SUBJECT: PALO VERDE NUCLEAR GENERATING STATION - REVISED REDACTED
VERSION OF RESPONSE TO INFORMATION REQUEST DATED
FEBRUARY 10, 2005

**Redacted Response to Information Request in NRC
Special Inspection Report 05000528/2004014;
05000529/2004014; 05000530/2004014**

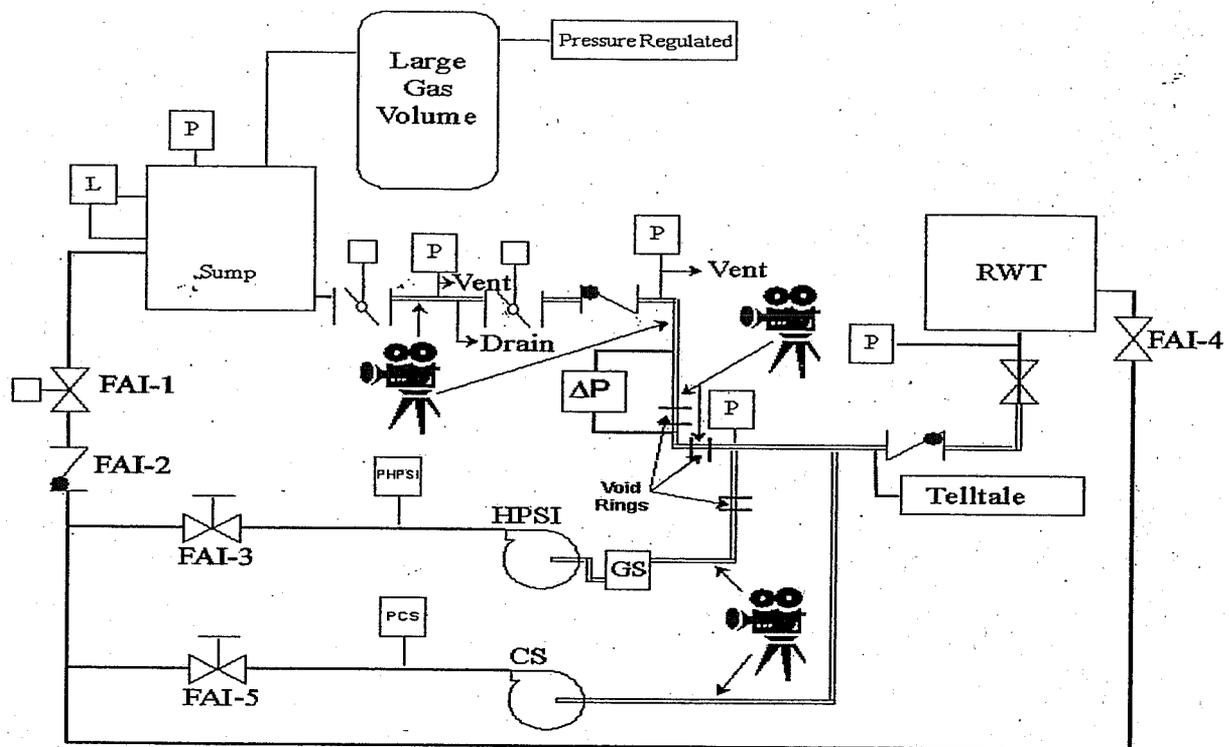
{Provide} a comprehensive account of the differences between the as-found configuration of the affected systems and the test configurations, including but not limited to the differences in components, process parameters, system operation and control, power usage, indications and environmental conditions.

The Phase 2 test facility was composed of two tanks with water inventories (the simulated containment sump and RWT), centrifugal pumps, piping, valves, a gas separator for the HPSI suction line and associated instrumentation as indicated in the following figure:

The piping and valves from the upstream isolation valve, the downcomer piping as well as the pump suction header were all 4 inch in diameter and fabricated from clear plastic to facilitate observation of the initial air inventory and its behavior during the opening of the MOVs. The major differences between the plant and the Phase 2 test loop can be categorized into five areas:

8 Influence of number of stages Z_n .

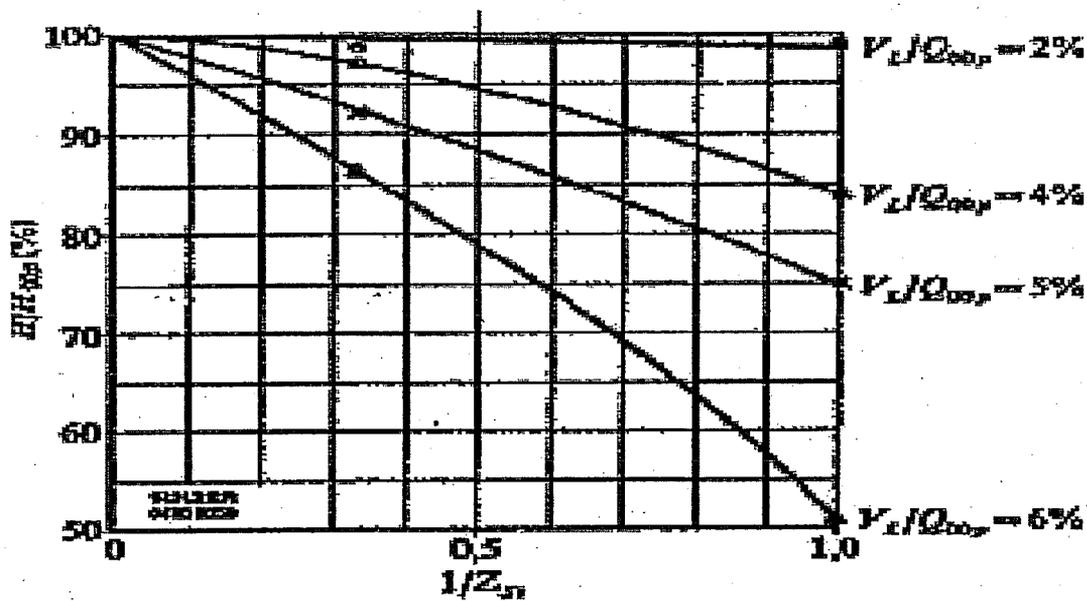
{Address} any differences between the predicted test results and the actual tests results.

The above figure provides reported performance degradation, in terms of developed head, for a single stage pump ($1/Z=1/1=1$) and for a 3-stage pump ($1/Z=.33$). As illustrated, pump degradation is much less for the 3-stage pump. The 8-stage HPSI pump ($1/Z=.125$) would be expected to experience even less degradation.

Typical Pump Performance Determination

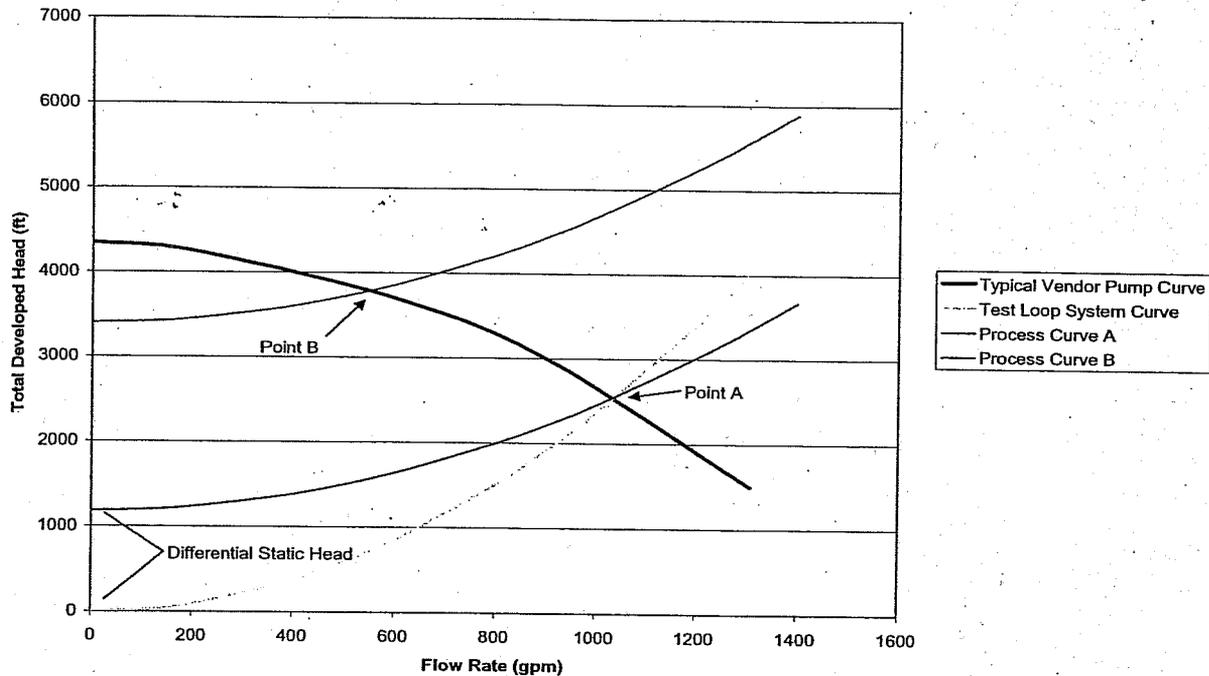
{Provide} a more comprehensive discussion on the scaling factors used to establish the test conditions for the full scale pump tests (e.g., system resistance).

As illustrated in the above figure, the pump's performance (developed discharge head and flowrate) is determined by varying the system resistance, usually by setting the position of a throttle valve on the discharge of the pump. The result is a test loop system curve like the yellow line in the above figure. For any centrifugal pump, its performance at a particular system resistance will be set at the intersection of the system curve and the pump curve. For this example, point A represents the pump's performance in a test loop at a representative point corresponding to a certain position of the discharge control valve. Varying of the position of the throttle valve by opening or closing the valve will decrease or increase the concavity of the parabolic shape of the example test loop curve, maintaining the same zero intercept. There is little or no static head component to the system curve since in most test loops the suction and discharge sources are the same. When placed in a process system, however, the pump's performance will be determined by the intersection of the process system curve and the pump curve. The process system curve may involve other elements in addition to system resistance. Two examples are illustrated in the above figure. The blue line (Process Curve A) would occur by a case in which a combination of differential static head and system resistance combine to produce an intersection with the pump curve at the same point as in the test loop. The system curve can be analytically developed using Bernoulli's extended energy equation. For the example illustrated by the blue system curve, the pump will produce the same developed head and flow rate as it did in the test loop, even though the system resistance in the process system is different than in the test loop.]¹

[The green line (Process Curve B) illustrates what happens when the same pump operates within a system with greater static head (e.g. due to increased system back pressure). Again, the intersection of the system curve with the pump curve (Point B) determines the pump performance. In this example, the pump would develop greater discharge head but less flow rate. The example illustrates how a pump's performance can be determined for process systems that have no relationship in terms of system resistance to that with which the pump was originally tested under. For the system being considered, the required variation in pump performance is the sole result of variations in static head with a fixed system resistance.

[Comparison of the ratio of the two-phase propagation velocities to the water sonic velocity for selected flow patterns
(Reference 4)]

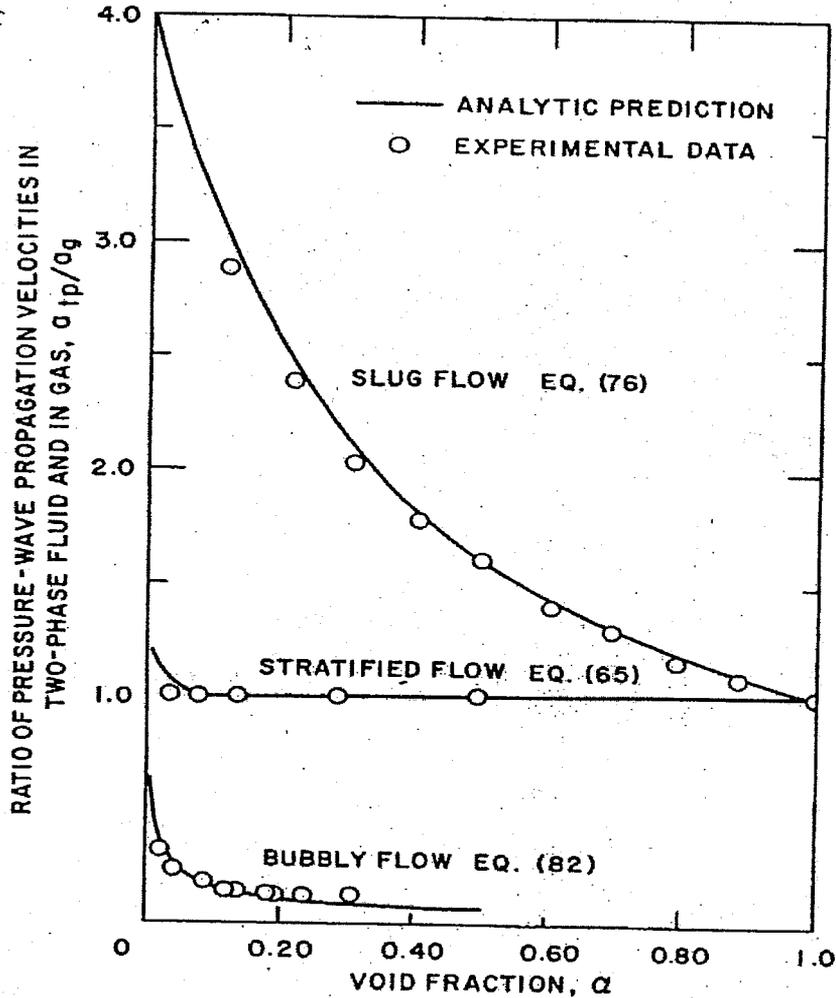
Address any potential negative impacts stemming from water hammers.

As illustrated, for stratified flow the pressure wave propagation velocity was reduced by a factor of four while bubbly mixtures experienced a reduction of as much as two-orders of magnitude. Consequently, a uniformly distributed gas volume will slow the response to transients (i.e., stabilize the flow). This is consistent with the example calculations provided by Martin (1976) – Reference 3.]¹
